Staff Report to the Plan Commission

Crossroads of Orland Park Mixed-Use Planned Development

Project: 2021-0286 – Crossroads of Orland Park - Planned Development**Petitioner:** Anthony DeAngelis, Inter Continental Real Estate & Development Corporation**Location:** 9551 W 159th Street and 16031 S LaGrange Road**P.I.N.s:** 27-22-100-028-0000 and 27-22-100-029-0000**Parcel Size:** 15.74 acres

LOT 2 – RESTAURANT “B”

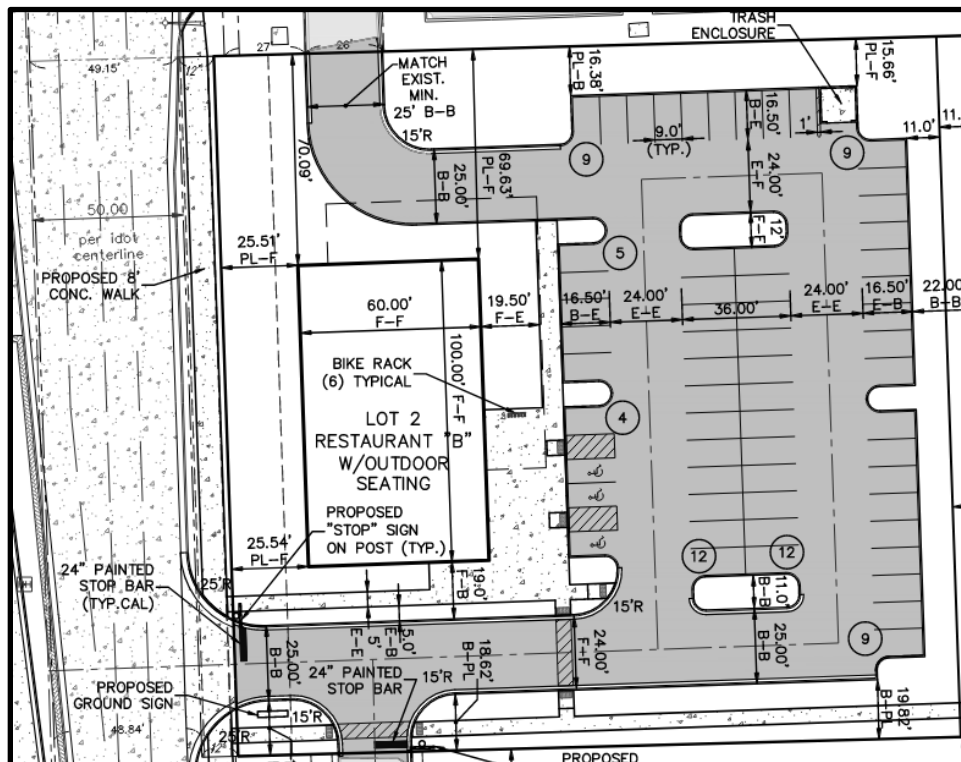
Lot 2 is a 55,781 square feet in size and would accommodate a 6,000 square-foot restaurant with outdoor seating. There is currently no restaurant user proposed for this parcel at this time, but the petitioner has requested a Special Use Permit for a restaurant with outdoor seating. For a restaurant user, Lot 2 is required to have up to 60 parking spaces on-site. Currently, 60 parking spaces and 6 bicycle parking spaces are proposed. The subject site will have direct vehicular access to LaGrange Road and 2 additional entrances via cross-access easements through the existing Pep Boys/NAPA and La-Z-Boy sites. A sidewalk exists on LaGrange Road, and a new sidewalk is proposed connecting Lot 2 to the residential parcel, Lot 5.

On the east of the site, north of the sidewalk connection to the residential parcel, a 22' landscape median separating Lot 2 from Lot 5 will contain a bioswale with native vegetation to enhance infiltration, filtration, and pollutant removal from surface runoff water in the parking lots.

Trash handling areas must be screened from view from public streets and any abutting properties by opaque walls. The trash enclosure is located on the east side of the main parking lot. The trash enclosure includes 6' masonry walls that will be required to match the main building, per Section 6-302.D. Signage landscaping will be approved during the sign review process.

There are no building elevations proposed for Lot 2 at this time. When a restaurant user applies to develop restaurant “B,” the proposed building footprint will have to be no greater than the 6,000 square foot building footprint illustrated on the site plan or else a Special Use Amendment must be granted. If the development complies with the approved site plan and landscape plan, staff recommends that restaurant “B” would proceed through the appearance review process.

1. The development will be in substantial conformance with the site plan prepared by DesignTek Engineering, revised December 19, 2023, and the landscape plan, prepared by Westwood Environmental, revised December 17, 2023.
2. The proposed building footprint is no greater than the 6,000 square foot building footprint as illustrated on the site plan or else a Special Use Amendment must be granted.
3. If the development complies with the approved site plan and landscape plan, the development may proceed through the appearance review process.

West Elevation

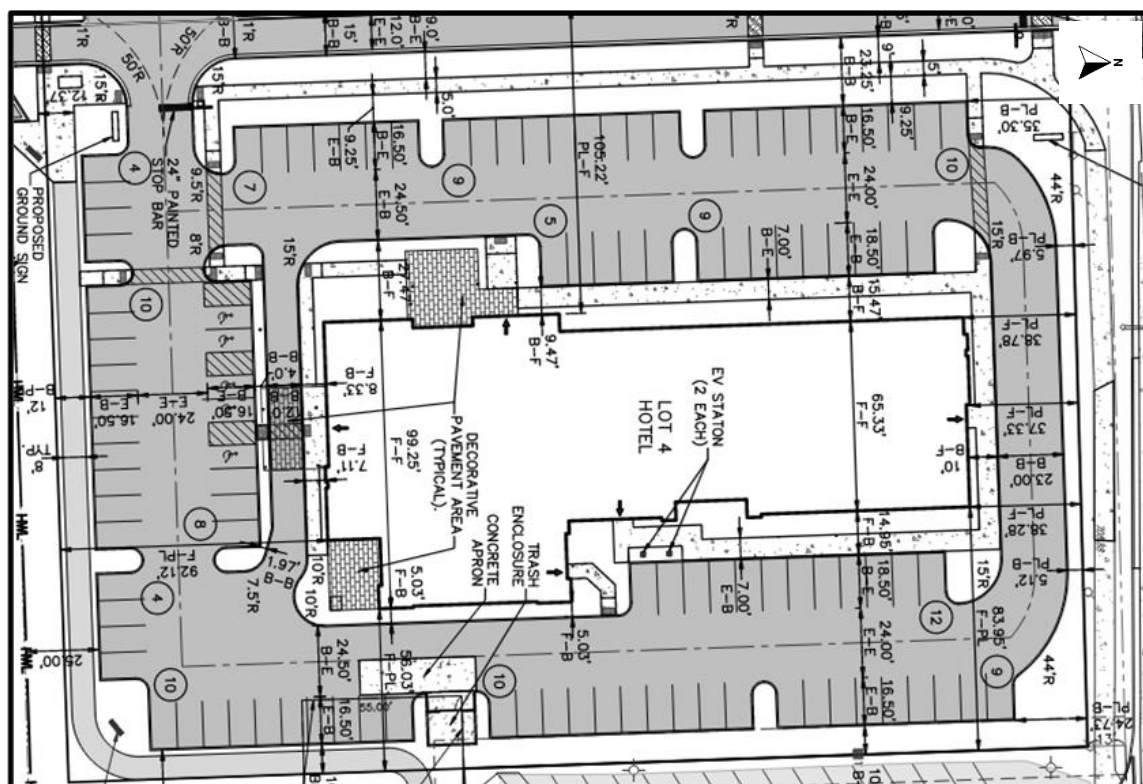
The west facing façade is very similar to the east but has a larger EIFS portion on the southwest corner of the building's upper floors. The first floor has the same stone material as the east side but has a large canopy over the outdoor patio on the site. The upper floors of the hotel are constructed primarily of brick in the color granite red and contain large windows throughout. Each floor is separated on the elevations with a brick soldier course pattern.

Side Elevation (with garage)

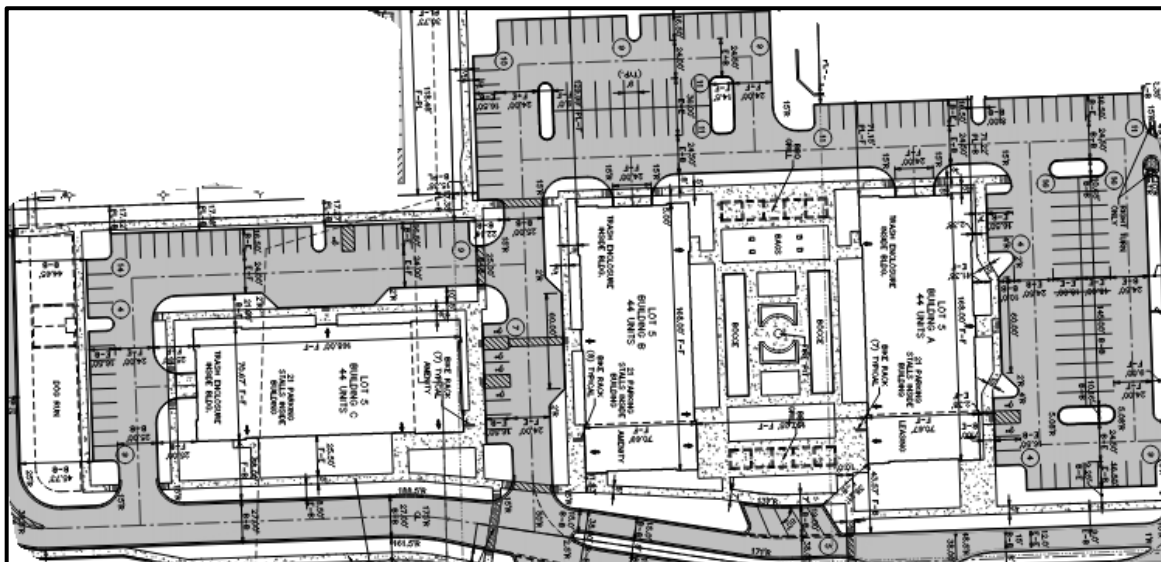
The side elevation with the garage is symmetrical with two balconies on each floor. The garage is centered on the first floor with windows on the corners. The 1st and 2nd floors are constructed entirely of red brick along with the corners of the 3rd and 4th floors. The 3rd to 5th floor recessed area on the center of the site is constructed of EIFS, along with the entire 5th floor.

LOT 6 – STORM WATER AND OPEN SPACE

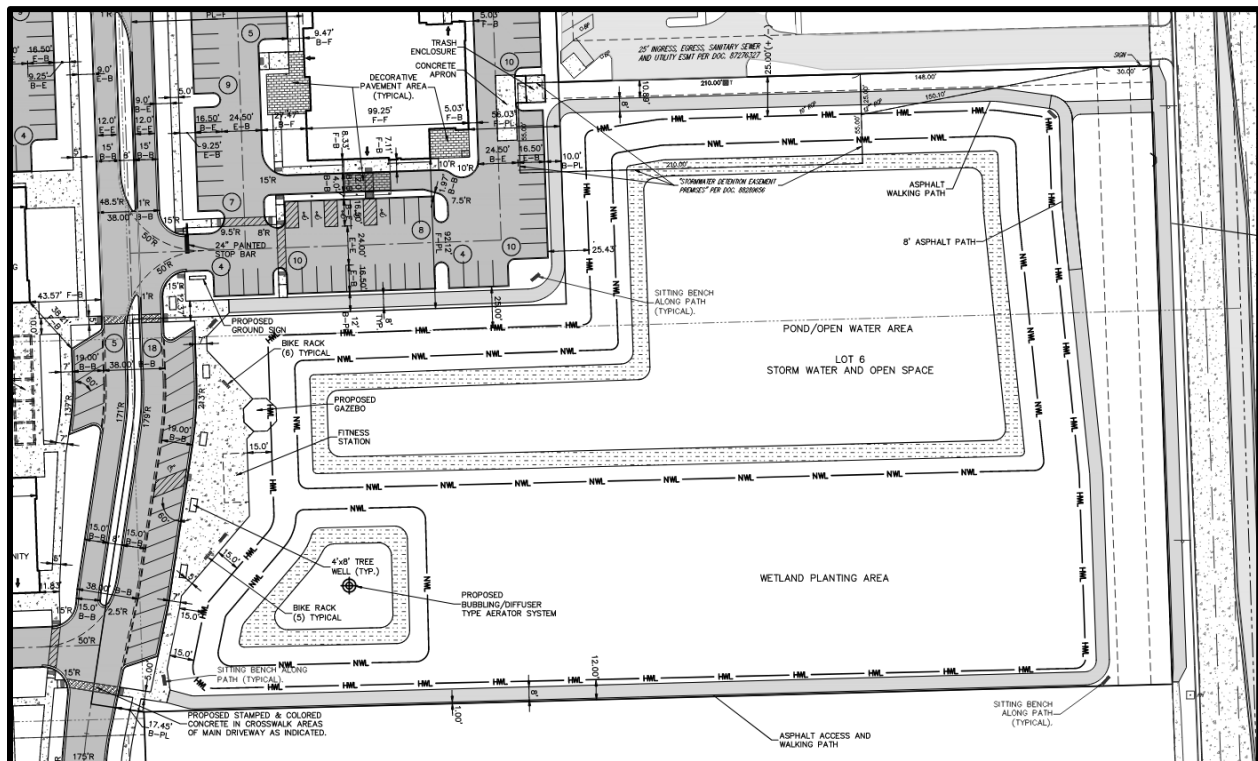
Lot 6 serves as the common open space and stormwater management area for Crossroads of Orland Park. There are 2 ponds and a wetland planting area proposed for this lot. Additionally, the open space area is equipped with a pathway encircling the entire site, complemented by benches, fitness equipment, and a gazebo that offers a scenic view of the fountain in the proposed pond. A special use permit has been requested to allow for the disturbance of a nontidal wetland, as detailed in the overall site plan section of this report. Additionally, modifications to the 25-foot setback and slope requirements for the pond have been proposed, specifically for the overlook area and the northern border of the pond along the hotel parcel border. Diagonal parking has been provided on lot 6 to accommodate use of this open space area and any additional residential guest parking demand.
